**STATE SIGNIFICANT DEVELOPMENT
ASSESSMENT REPORT:**

**Stage 1 Development, Acute Health
Service Building, Campbelltown Hospital
Lot 6 DP 1058047, Appin and Therry
Roads, Campbelltown
(SSD 5003)**

Director-General's
Environmental Assessment Report
Section 89H of the
Environmental Planning and Assessment Act 1979

November 2012

Figure 5: Gabion Wall – Applicant's Precedent Image

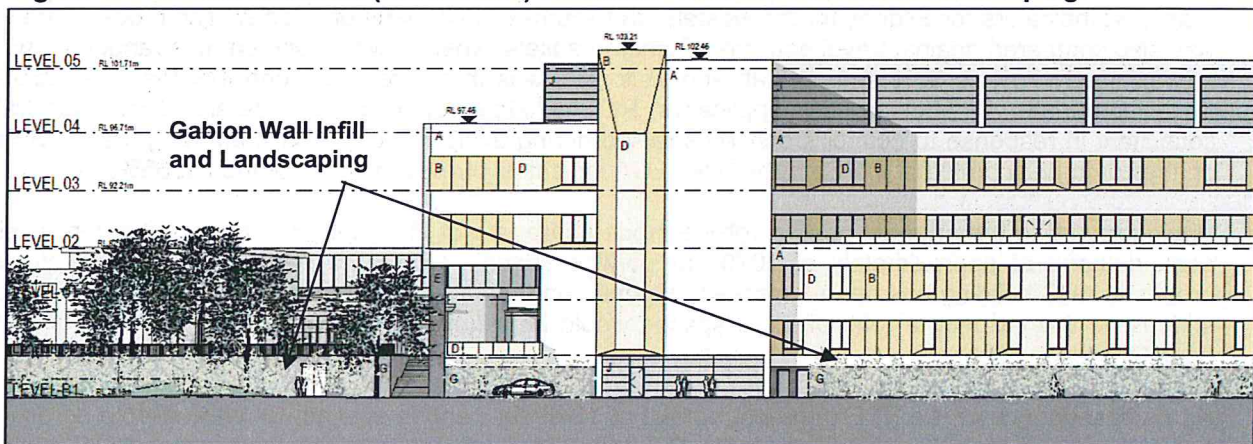
Concerns were initially raised by the department and council about the design and appearance of the proposed six storey AHS building, specifically the large empty void spaces at lower floor levels, lack of street level activation and large bulky nature of the projected stairwells.

The applicant advises the floor to ceiling height of the lower levels would not permit clinical services operations, only management and administration hospital functions. However, the applicant states that no additional hospital administration functions are currently proposed. It is possible that the void spaces would be suitable and capable of providing future ancillary retail uses.

In the absence of an ancillary retail use being proposed, the applicant has proposed an interim façade design solution at the interface with Parkside Crescent. This has been achieved through the provision of infill stone gabion wall panels, which can be easily removed and recycled in the future should retail/hospital administration functions be established within the lower floor levels. Landscaping along the street frontage will be integrated with the proposed gabion wall treatment, which will provide a positive design response to the character of the open space opposite (see Figures 4 and 5). A condition is recommended to be imposed to ensure that landscape screening is provided to the gabion walls to ensure they address the public domain satisfactorily.

Figure 6: Hospital Car Parking Locations

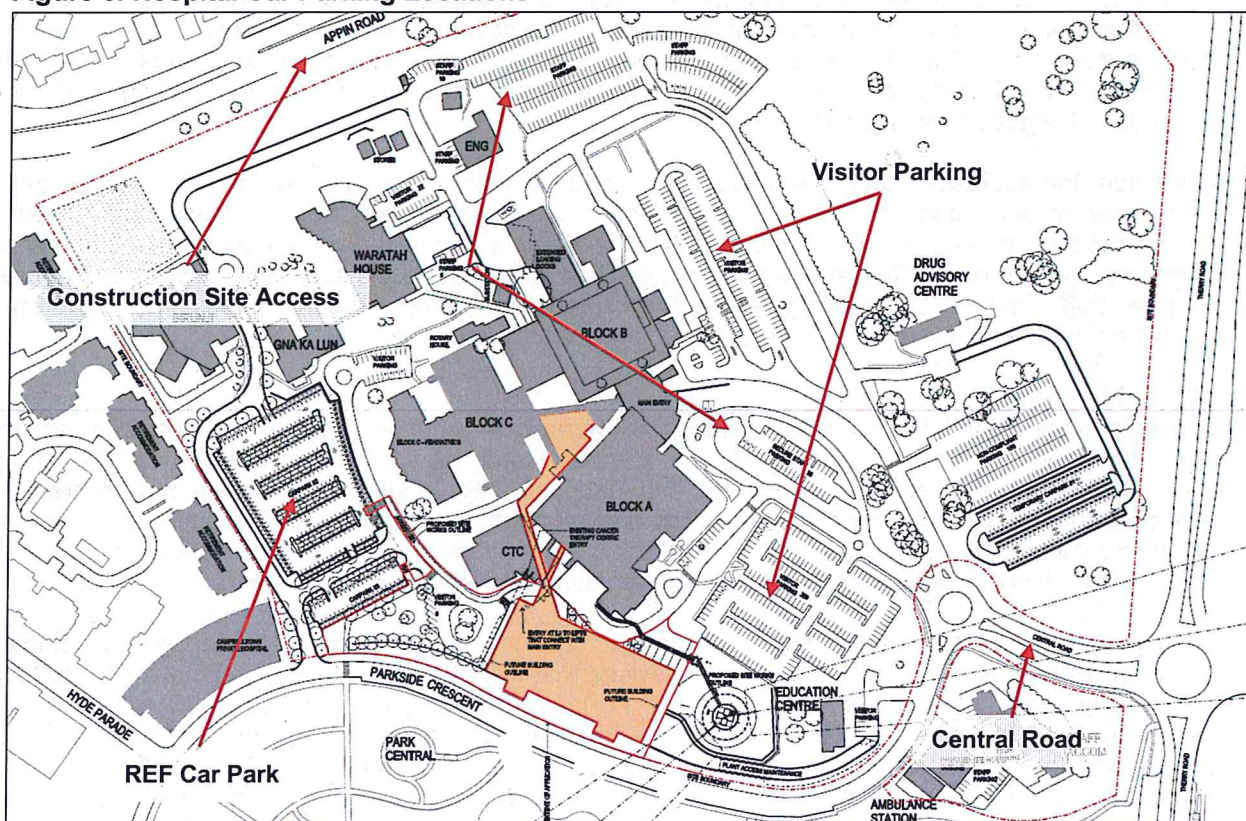
Notwithstanding, concern is still held by council that the parking demand of the existing hospital functions has been under-assessed and that despite the 248 new parking spaces approved under the REF, there will still be a shortfall of parking for the overall hospital campus when completely operational. The department holds similar concerns and as such, it is recommended that an additional overflow car parking area, with a minimum capacity of 100 spaces, be provided to account for the potential future shortfall in parking spaces.

Council is concerned that the current approved REF design, providing direct vehicle access to and from Parkside Crescent, will create a significant adverse impact on the existing road network unless necessary road widening and/or additional parking facilities are provided as part of the proposed development.

The department also notes that a significant amount of hospital visitor parking, and the majority of existing car parking provided, is located off the main Central Road access point, adjacent to the existing main entrance of the hospital (see Figure 6), further encouraging the use of Central Road as the main access point. In addition, correspondence was received from the applicant following meetings held with council, advising that Health Infrastructure is happy to continue to work with council and RMS to explore future access options to the hospital campus to help disperse and manage traffic flows.

In this regard, having considered council's continued concerns regarding the proposed increased use and existing capacity of Parkside Crescent and its ability to continue operation at a satisfactory level of service, the department considers investigations into the establishment of new permanent vehicular access off Appin Road should be explored. In this respect, temporary construction vehicle access has already been approved by the RMS, providing construction vehicle access directly from Appin Road. Accordingly, a condition is recommended requiring new vehicle access to the hospital campus be provided via Appin Road for emergency vehicles in the first instance and then, staff and visitor vehicles. Notwithstanding, the establishment of new permanent vehicle access from Appin Road is dependent on the support and separate approval of the RMS.
